The Sandstone Precinct: MOD 7 Design Report

Document Number
SP-RPT-E-MAKE-0005

MOD 7 Design Report

Basement level 03

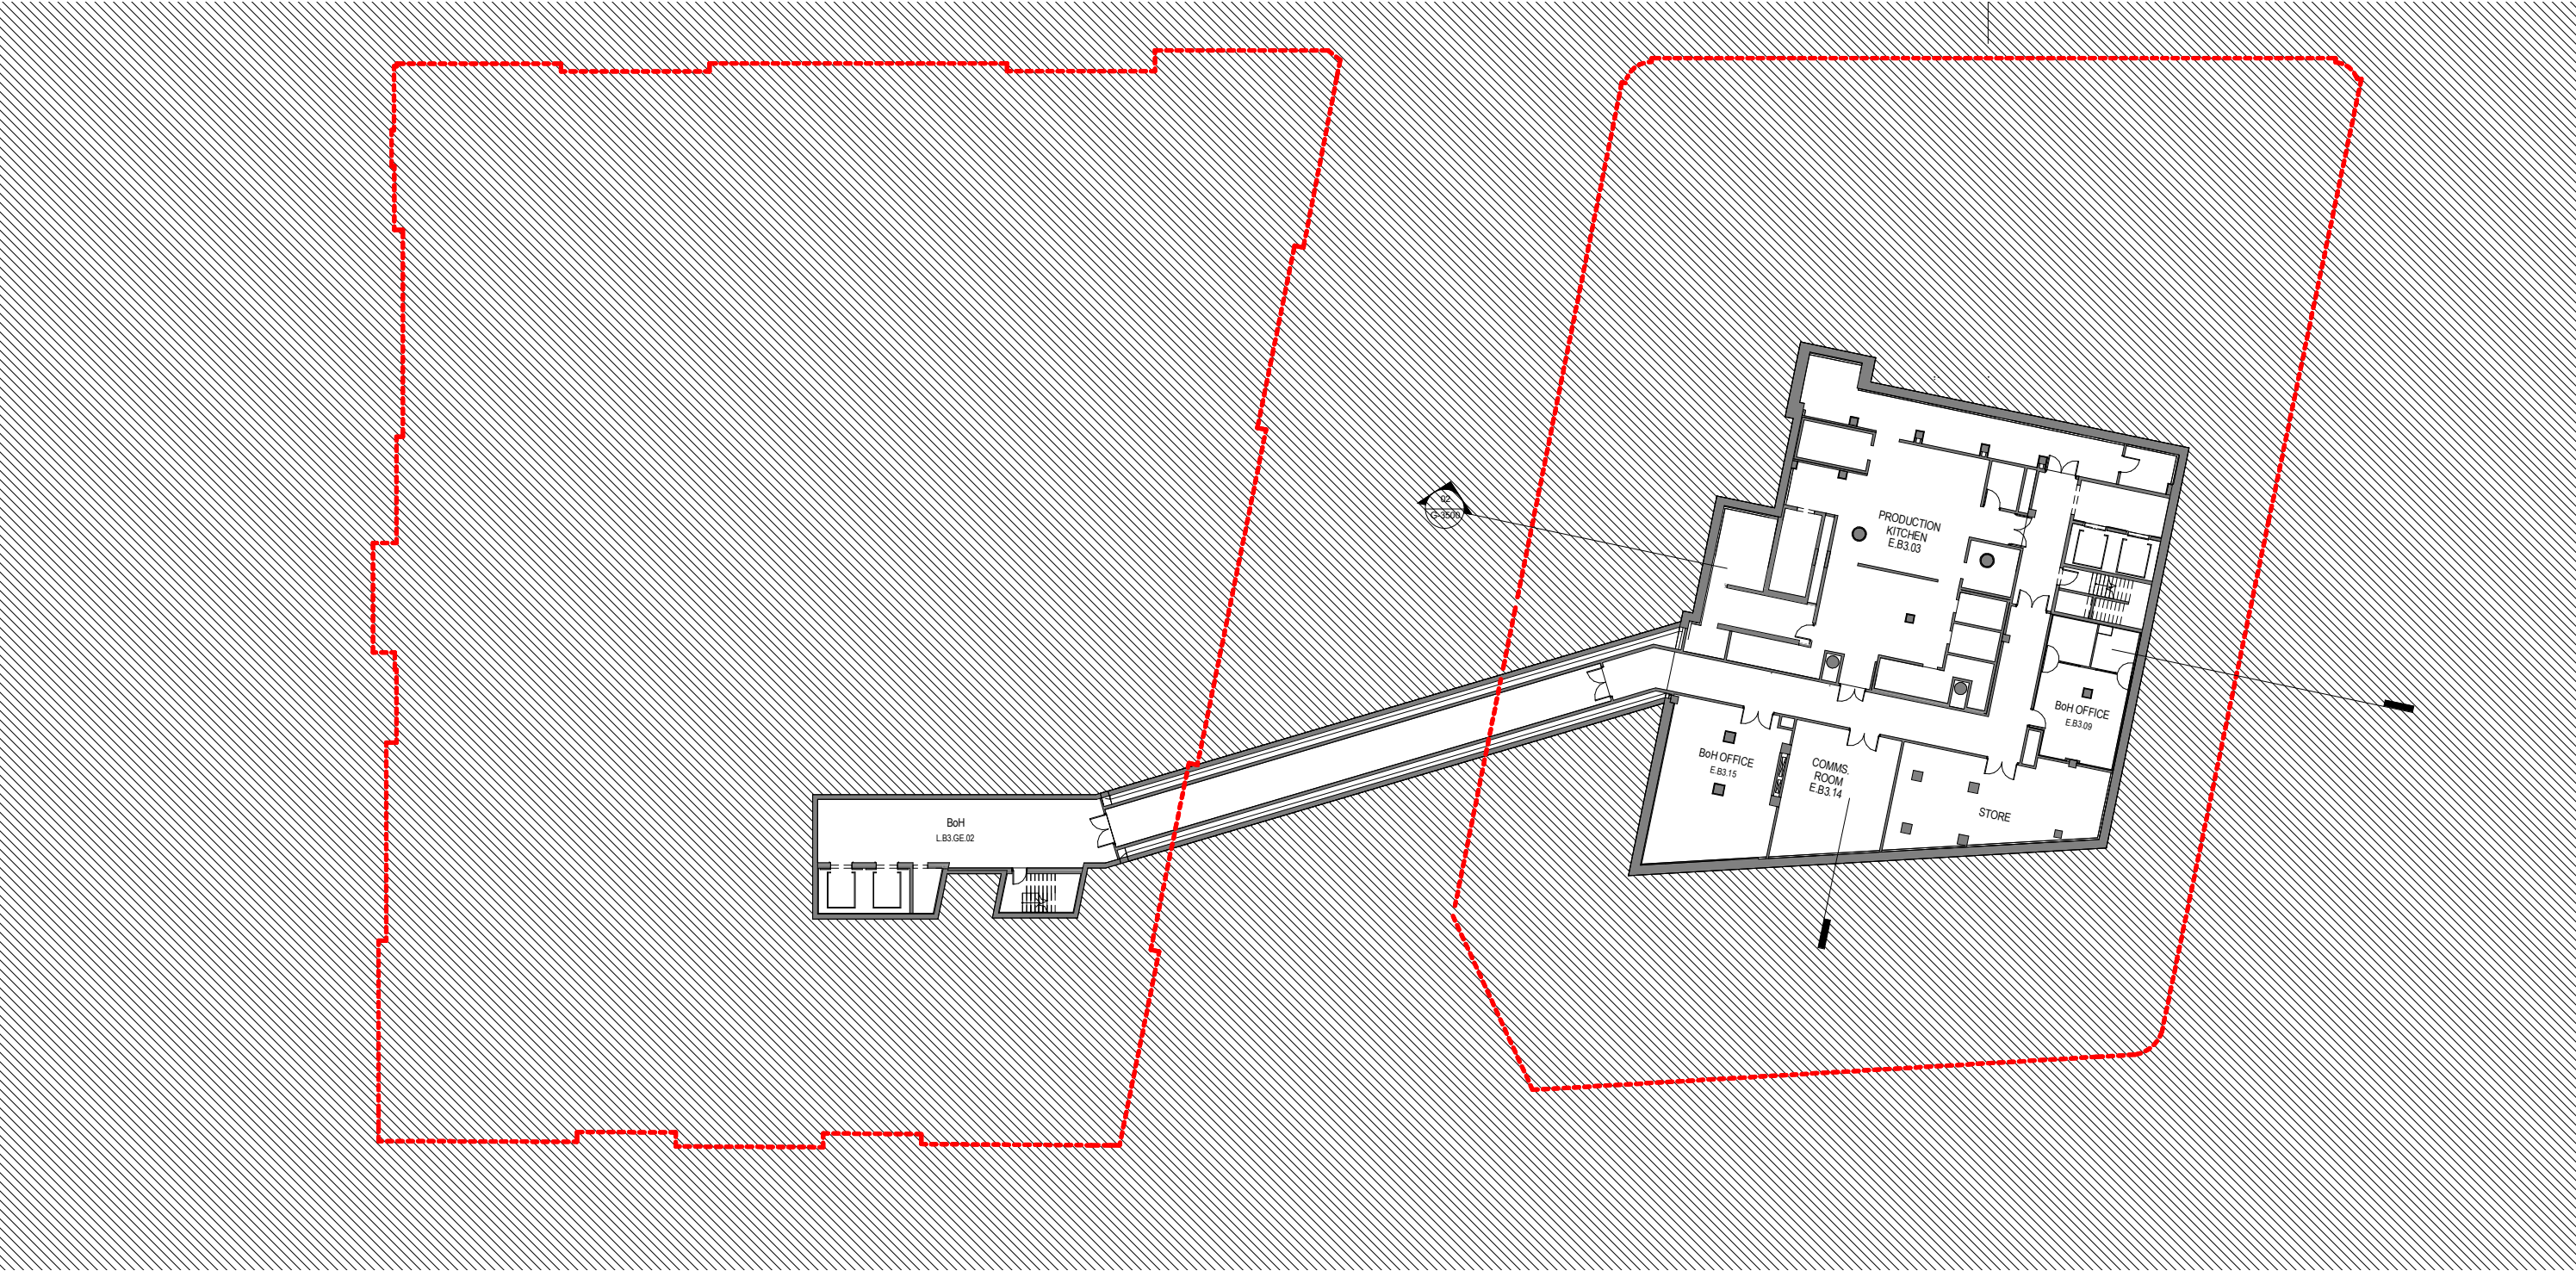
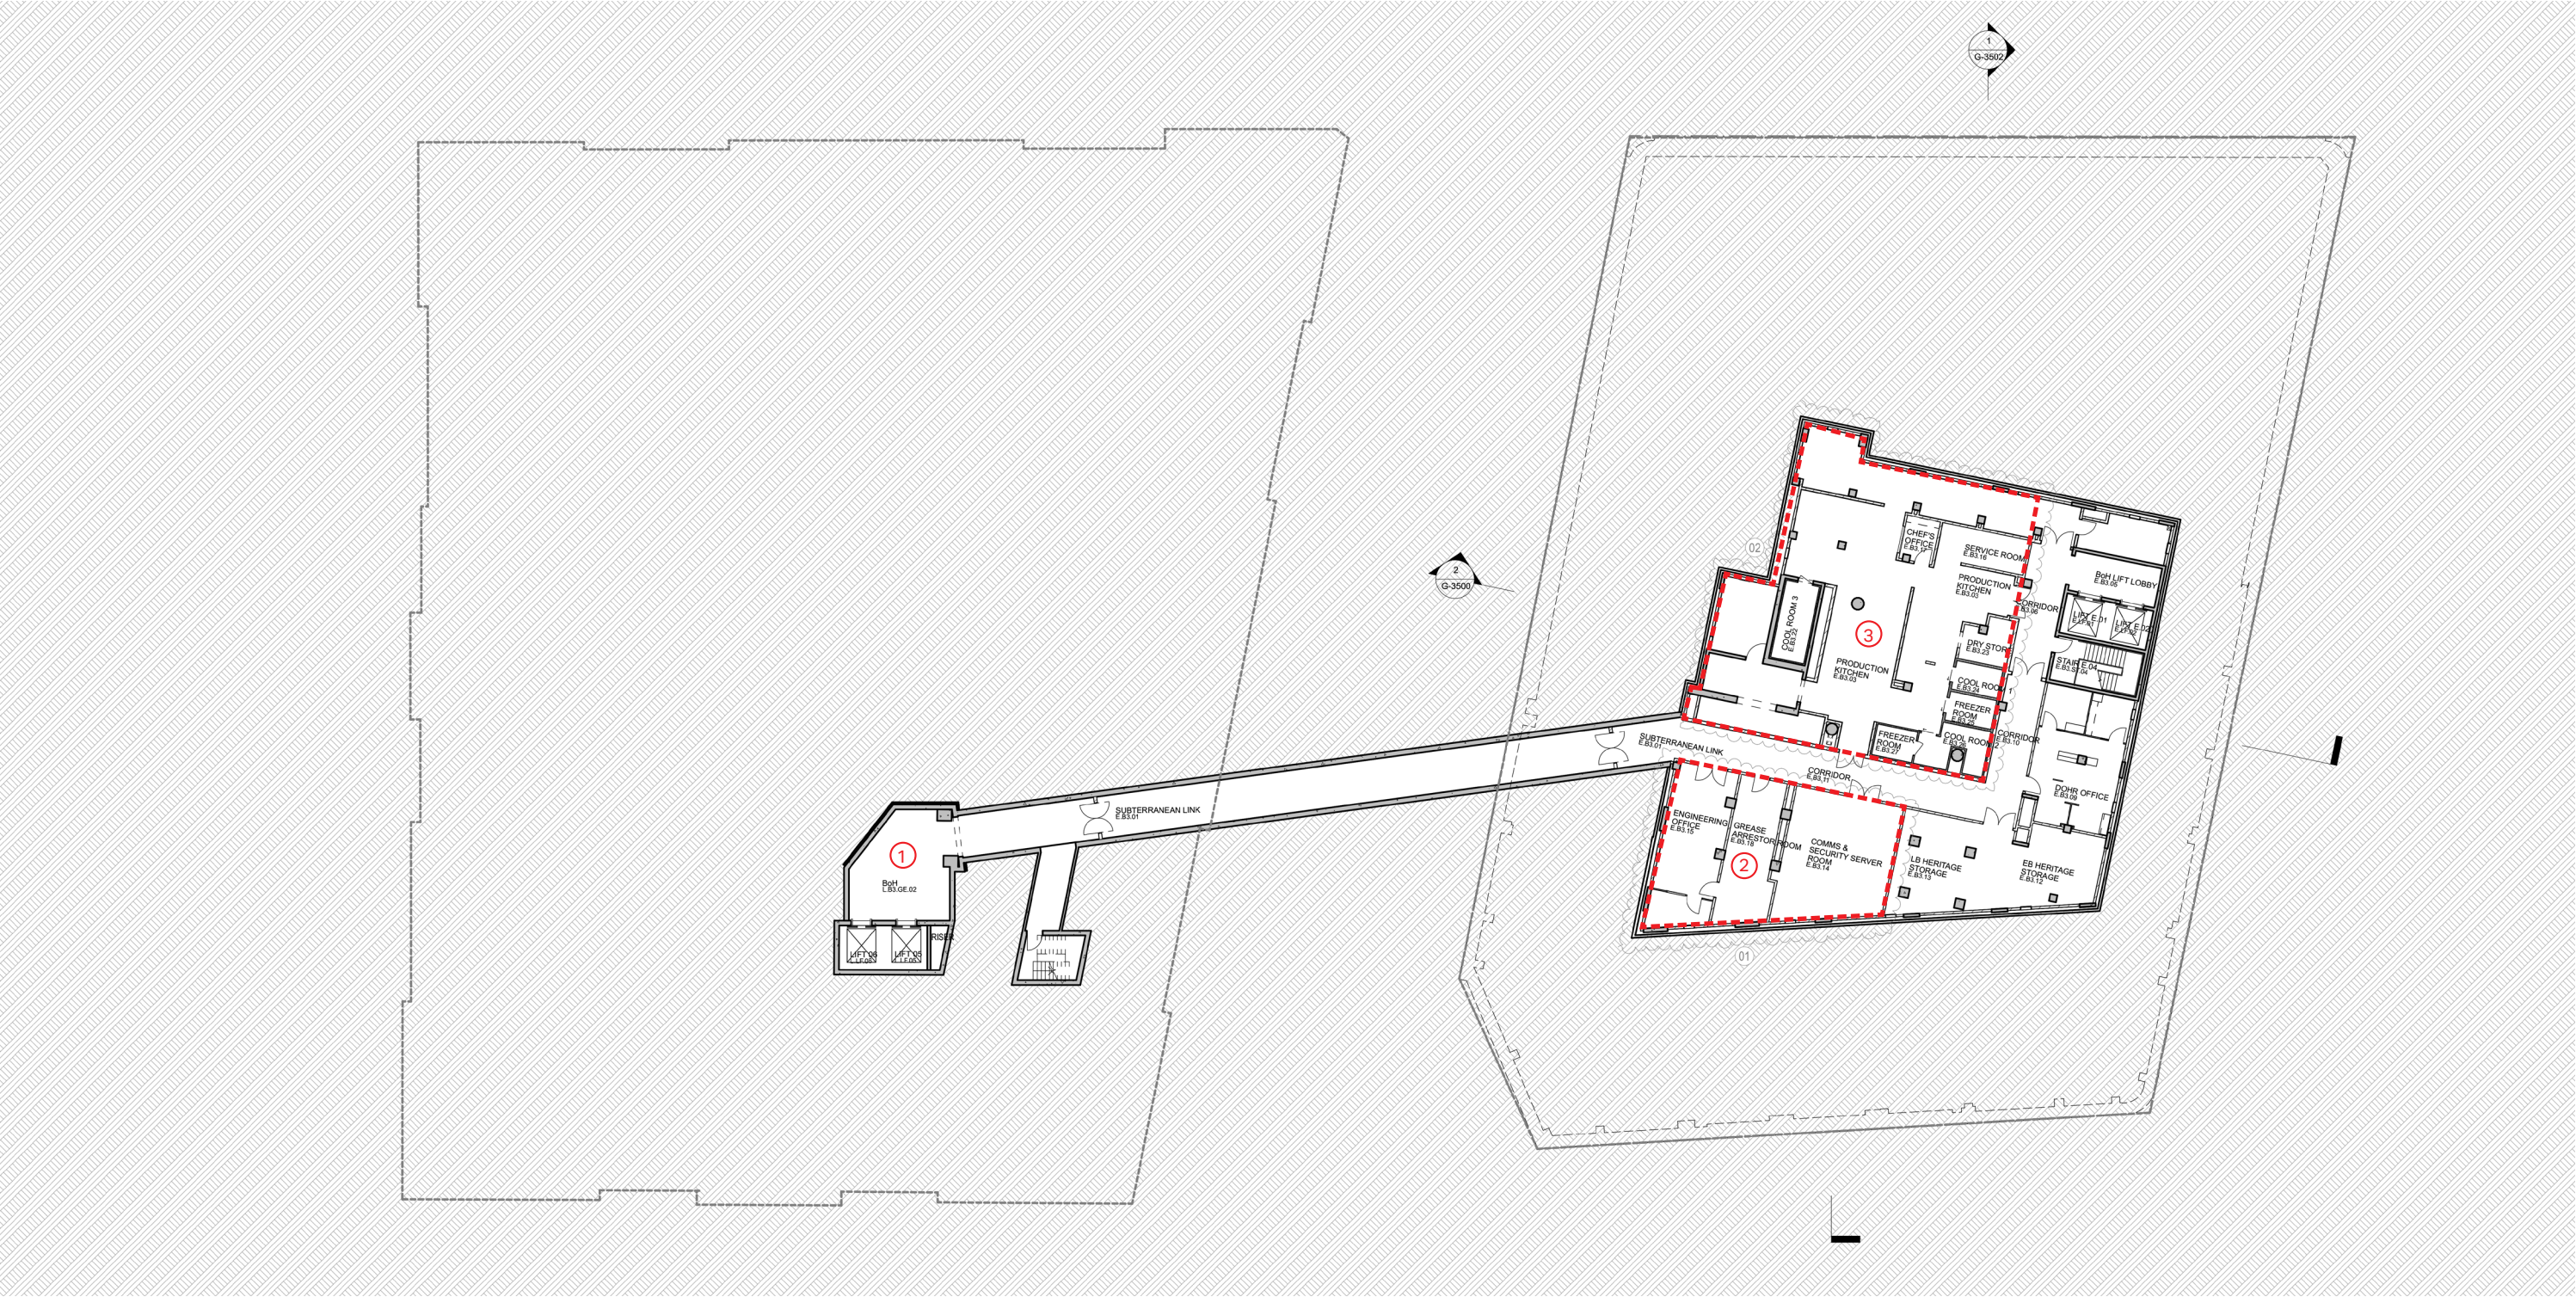
- Notes**
- 1. The changes to the Lands Building and subterranean link are subject to a separate planning modification application. They have been shown here to understand the connection to the Education Building only.
 - 2. Grease arrestor room relocated to south-western corner.
 - 3. Production kitchen layout reconfigured

Basement level 02

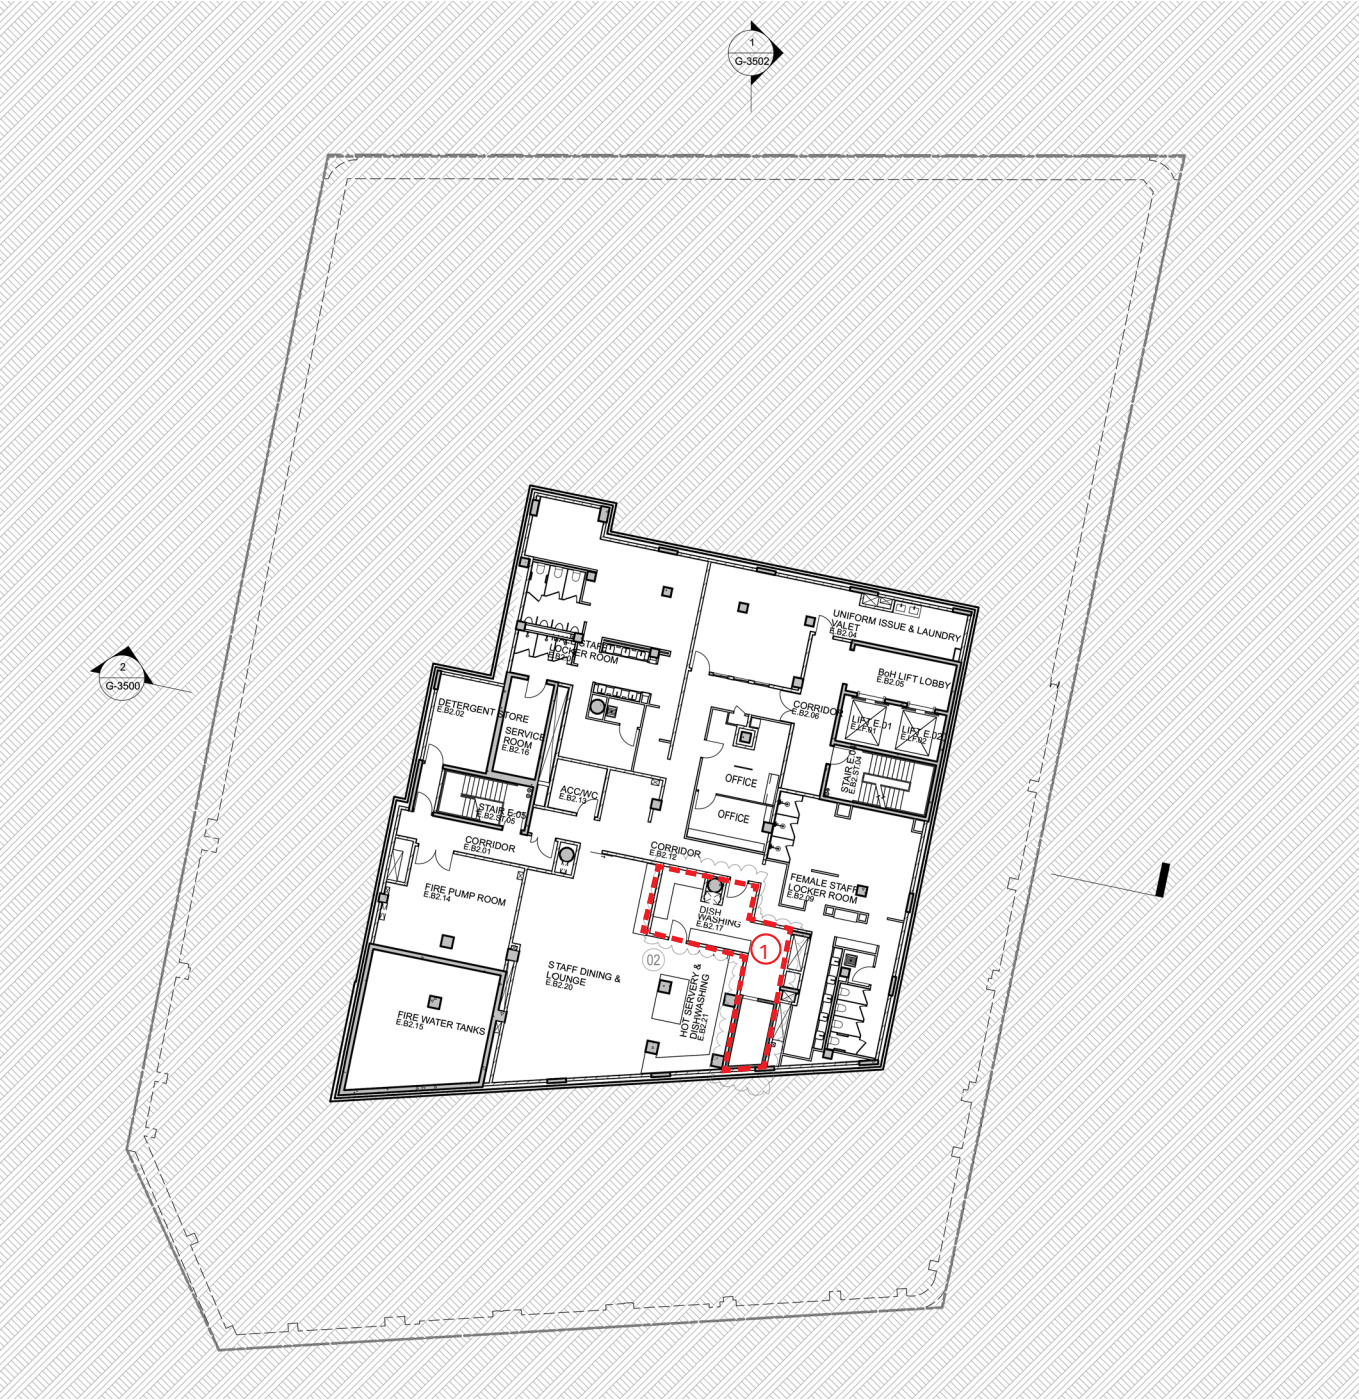
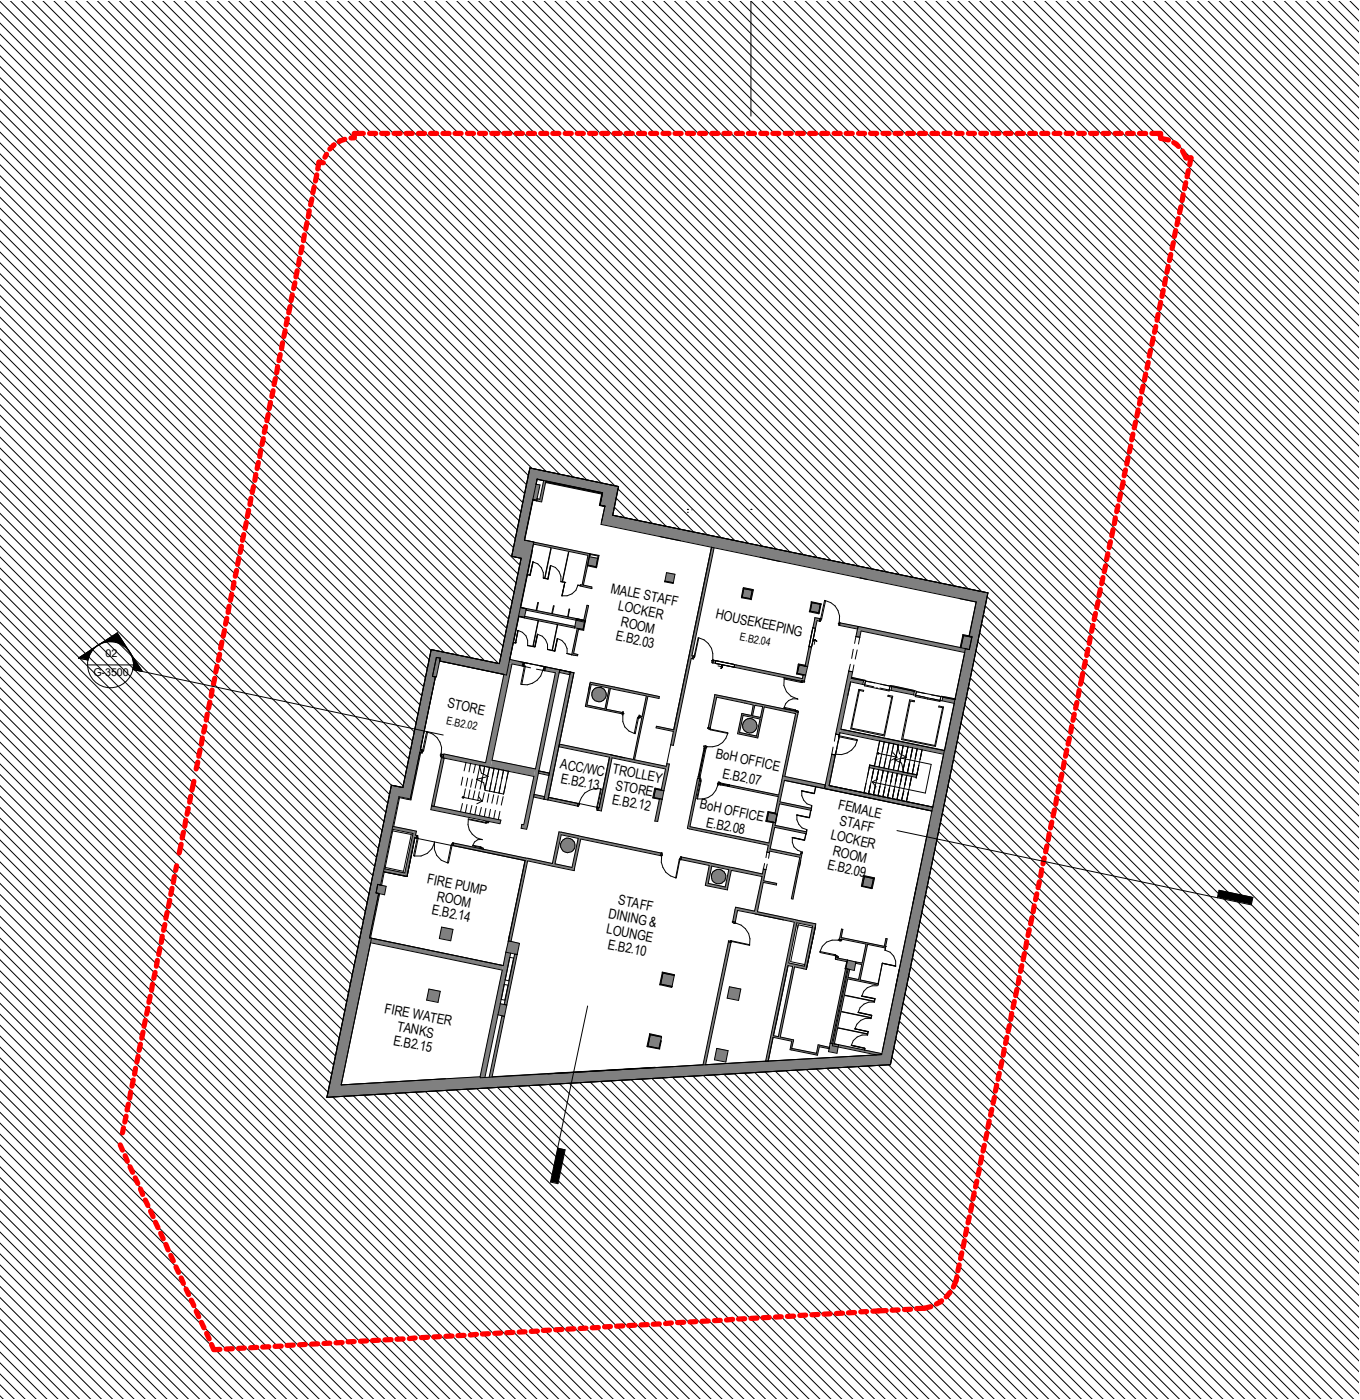
- Notes
- 1. Redesign of staff dining to include dish-washing and cool room
